924 N. MAGNOLIA AVE– MIXED USE

SUMMARY

Staff recommends approval of 924 N. Magnolia Ave Multi-Family and Mixed Use project—MPL2022-10053 subject to the conditions below.

Proposed Landscape Plan

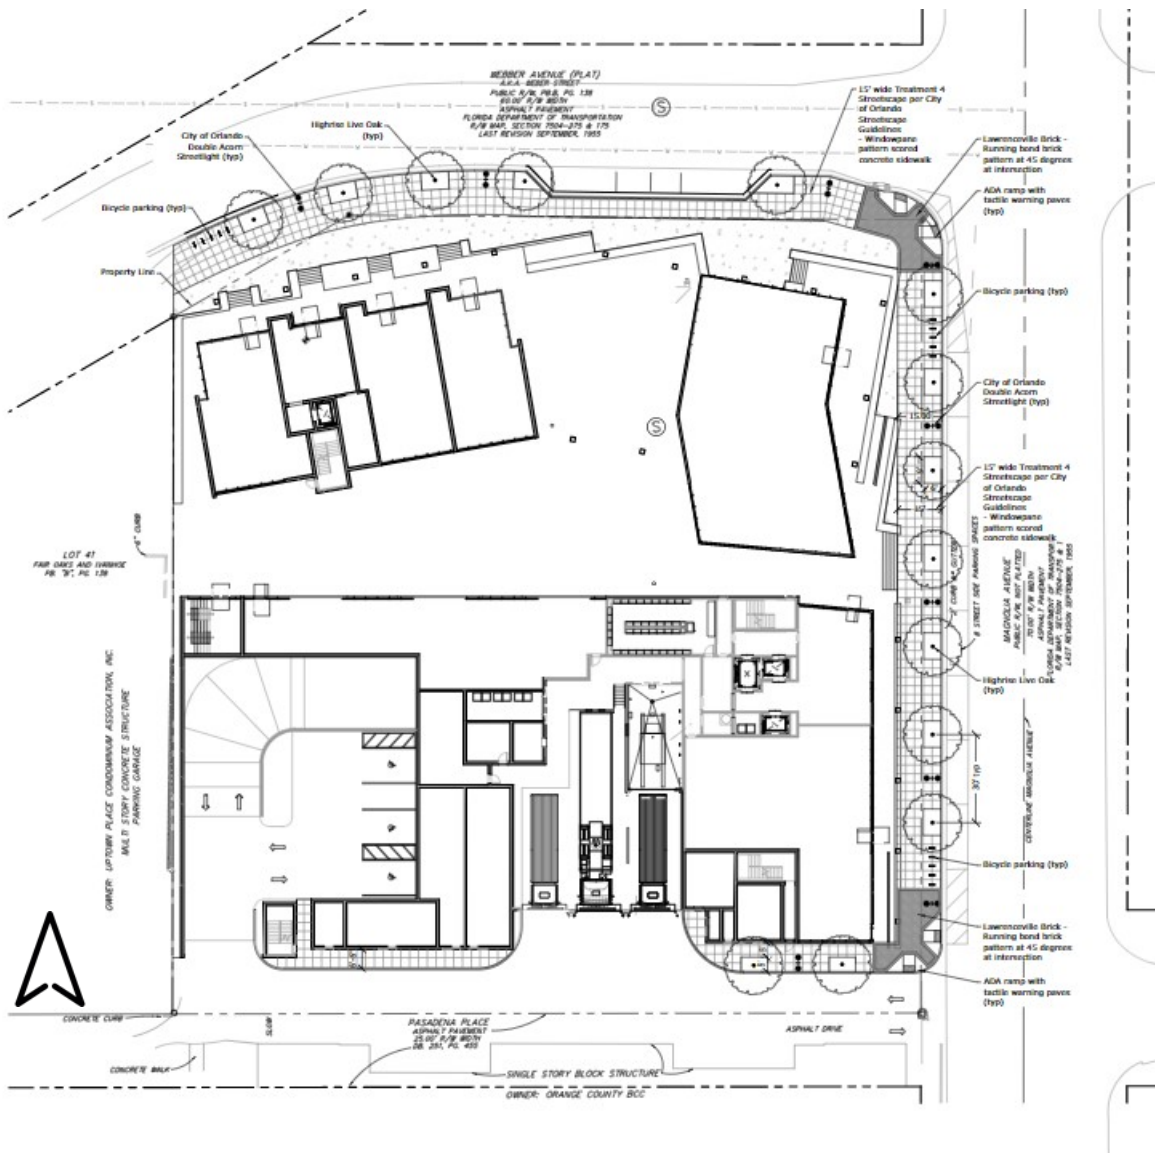
Landscape and Hardscape Plans—Detailed landscape and hardscape plans including the buffer area to the east must be submitted with the ARB Final Review application and must be approved prior to issuance of foundation permits.

Landscape. A. Landscape of the plaza and garden areas requires additional information and refinement.

Proposed Building Elevations

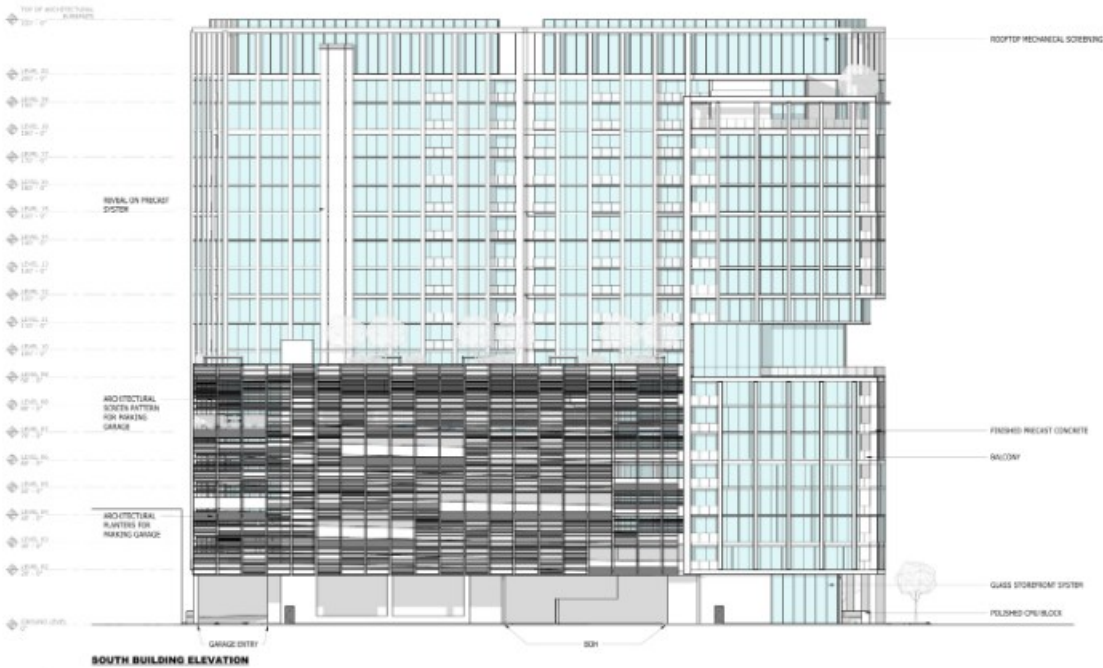
Architecture Design Intent—ARB staff has minor concerns about the proposed design in the current proposal and staff believes the project design, at this Courtesy Review level, still needs additional refinement, articulation and screening so the building design is both cohesive and distinctive. ARB staff will continue to collaborate with the development team in order to advance the building design and to help deliver a distinctive project that will enhance both the Orlando skyline and city life at the street level. The final ARB submittal must include a comprehensive overview of the project including dimensioned site plans, landscape, hardscape, utilities, signage and lighting plans. Architectural floor plans, 2D line elevations, sections showing the garden relationship to the towers and garage, color elevations with detailed material callouts, details showing design intent, physical material samples where needed, 3-D massing studies and color perspective renderings showing both day and night views from all corners.

Design—The parking garage podium shall have a solid opaque wall 42 inches high at all parking levels to block vehicle views. The parking garage is partially screened with panels and planters that need additional elaboration. More information is required on the visibility of the west façade of the garage and the internal garage facade. The west façade may require additional treatments. More detail shall be required for the garden/plaza areas.

Skyline Architecture – Refinement will be needed at the top so that there is interest and enhancement of the city skyline so the building is unique and easily identifiable in the downtown skyline during the day and night. Recommend that the western most tower have additional height or eastern tower is somewhat reduced so that there is a height difference for each of the three tower elements.
